Certificate of Appropriateness

BAR 21-11-02

106 Oakhurst Circle, Tax Map Parcel 110005000

Project: Landscaping plan

SITE/LANDSCAPE PLAN

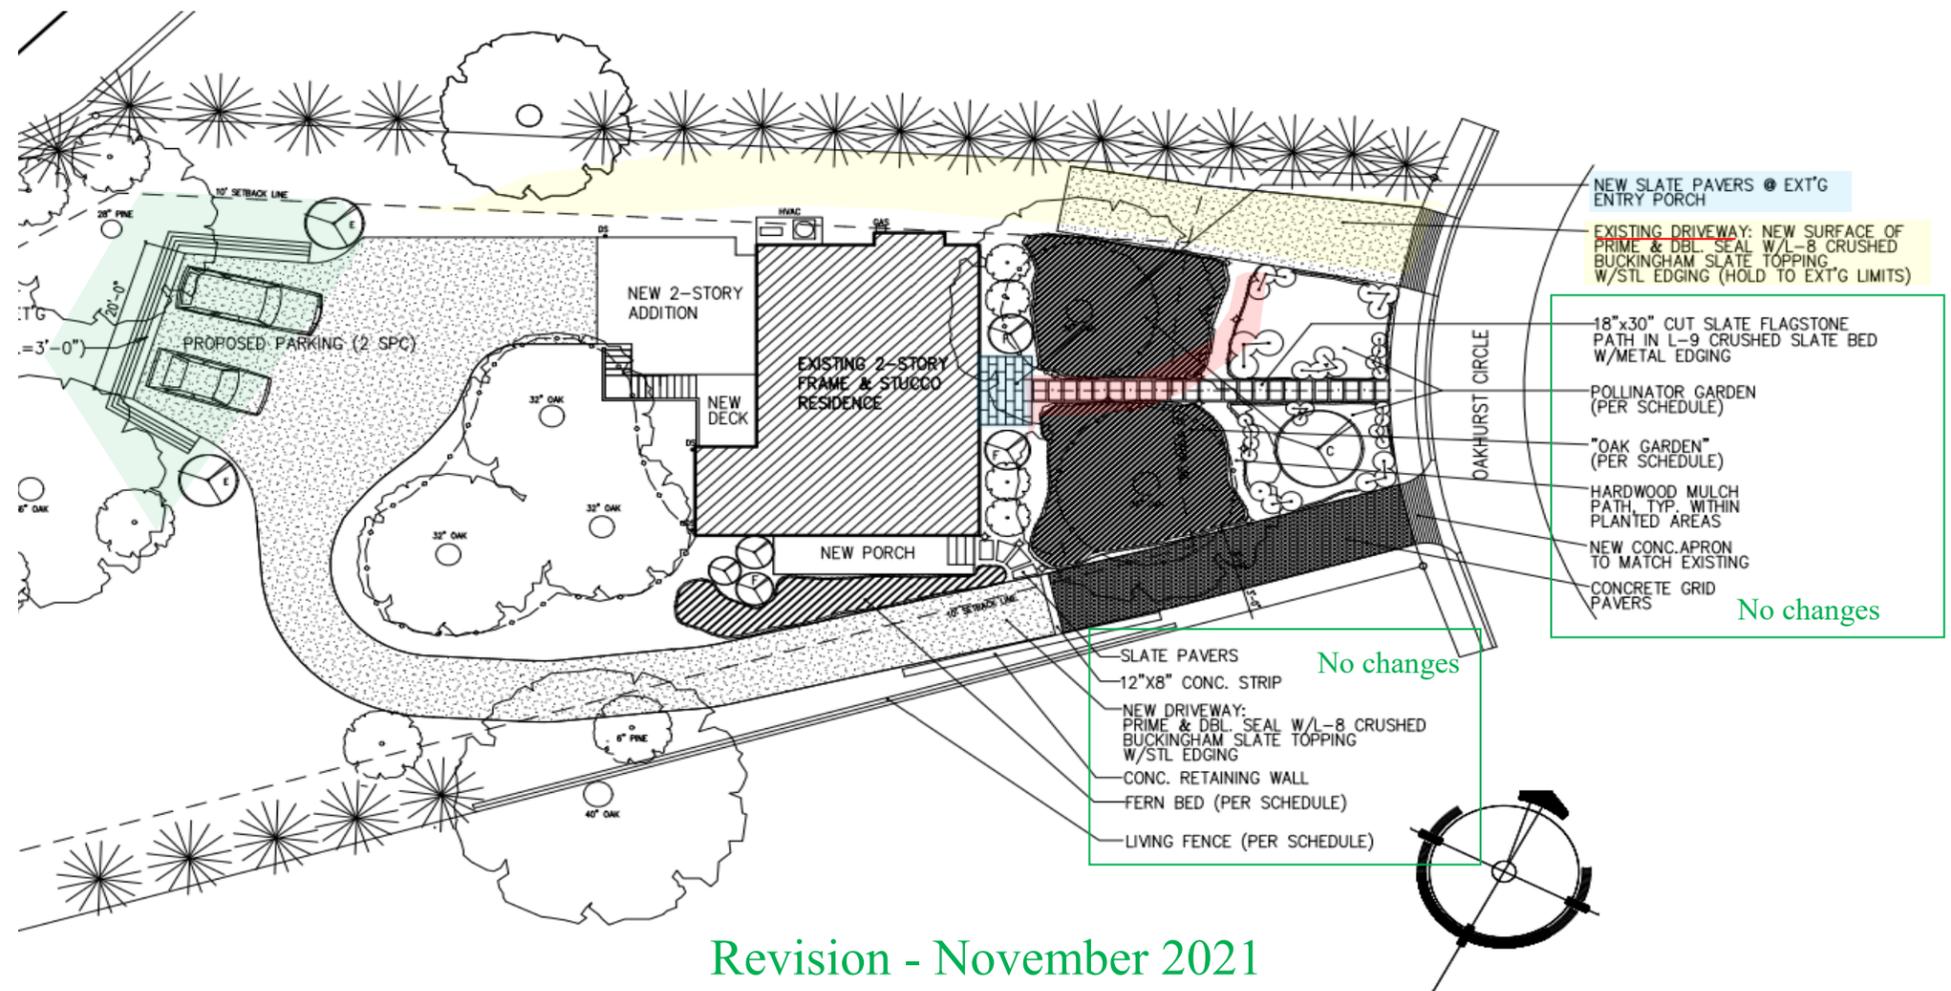
- *that the existing parking spot be removed and that the area be landscaped consistent with the landscaping plan for the adjoining front yard area*
- *that the granite curbstones being removed for the new driveway be reused to enclose the existing driveway curb cut.*
- *Additionally, the BAR recommends the city traffic engineer allow flexibility relative to the required driveway entrance width.*
-

Previously, the existing driveway (along the north parcel line) was eliminated and a new constructed (along the north parcel line). The project will now retain the existing and use the new ~~to create a loop~~ for access to and egress from the parking area behind the house.

To allow flexibility in the required placement and width of the new driveway—for ex., to minimize removal of the existing stone curbing--City Code Section 34-972(a)(5) allows for the BAR to make recommendations to the city traffic engineer. The suggested motion for approval includes that recommendation.
